**Re: FortisBC Energy Inc. (FEI)**

**Application for a Certificate of Public Convenience and Necessity (CPCN) for the  
Tilbury Liquefied Natural Gas Storage Expansion (TLSE) Project (Application)**

**Response to My Sea to Sky (MS2S) Information Request (IR) No. 6**

**Figure 3-8: Timeline for AV-3 Service Restoration (with AMI)**

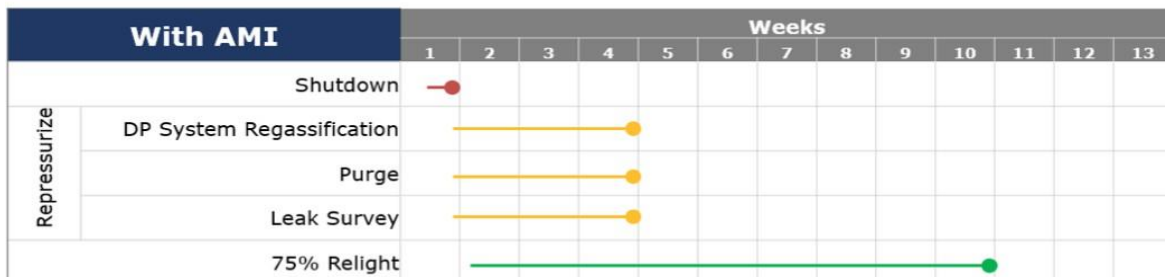
1.3 Please elaborate on the role of automatic shutoff sensors, which detect pressure drops in the input supply, and shut off the meter’s (and/or appliances’, many of whom have their own pressure loss shutoff sensors) inlet valve in a significant loss of pressure on T-South. In particular, why would these not all trigger long before the onset of “hydraulic collapse” conditions, thereby reducing /eliminating the need for relights and hastening the early return to economic activity?

Further, appliances will need to be relit when a gas meter has been shutoff for any reason. As shown in Figure 3-8 from the Supplemental Evidence (reproduced below), this relight process drives much of the service restoration duration. Thus, even if the automatic shutoff sensors were technically possible, they would not reduce or eliminate the need for relights.

**Figure 3-8: Timeline for AV-3 Service Restoration (with AMI)**

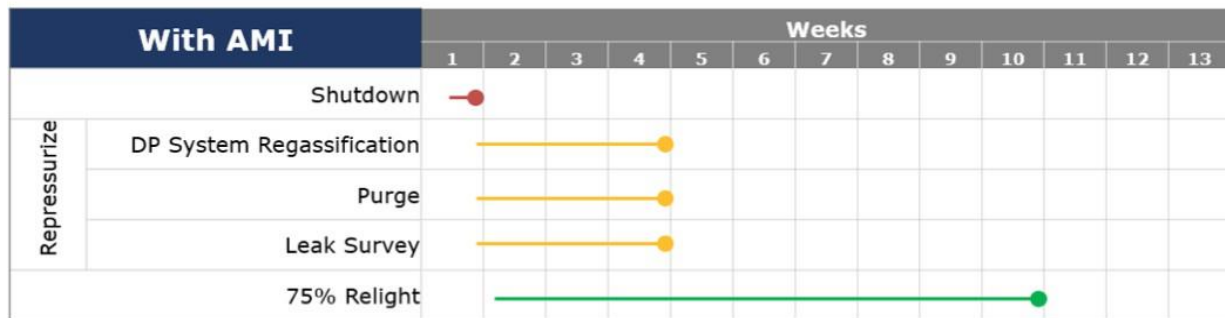
- 3.1 Please explain why, with AMI in place for the “vast majority of customer accounts”, FEI “*will be unable to initiate a controlled shutdown before the system depressurizes in an uncontrolled manner*”.

- 3.2 If the above statement is true, and a hydraulic collapse is inevitable no matter the presence or absence of the TLSE tank, why is there any need for TLSE?

Even with AMI in place, AV-3 is expected to result in an uncontrolled shutdown for the following reasons:

1. While customer meters equipped with the remote disconnect feature could be shut-in remotely (i.e., the remote shutdown customers), the remaining customers (i.e., the manual shutdown customers) would have to be shut-in manually. During the time it takes to execute this operation, these customers would continue to consume gas. Please also refer to the response to MS2S IR6 1.5.
2. FEI’s existing resiliency capabilities (i.e., without the TLSE Project, but including AMI for the purposes of the 2024 Resiliency Plan) do not provide a long enough load support duration to maintain system pressure while the manual shutdown customers are shut-in, and as such an uncontrolled shutdown would occur.

3. A controlled shutdown takes time to implement. To avoid the situation where FEI unnecessarily shuts-in its customers, FEI must be confident that doing so is the optimal decision. Receiving the full information required to make such a decision requires time. As such FEI remotely shutting in the vast majority of its customers shortly after the rupture incident is not a realistic scenario.

The question incorrectly states that a hydraulic collapse is inevitable no matter the presence or absence of the TLSE tank. This is incorrect. Figure 3-8 from the Supplemental Evidence represents the restoration timeline for AV-3 under FEI's existing resiliency capabilities. It does not represent the scenario wherein the Preferred Alternative (Supplemental Alternative 9) is in place.
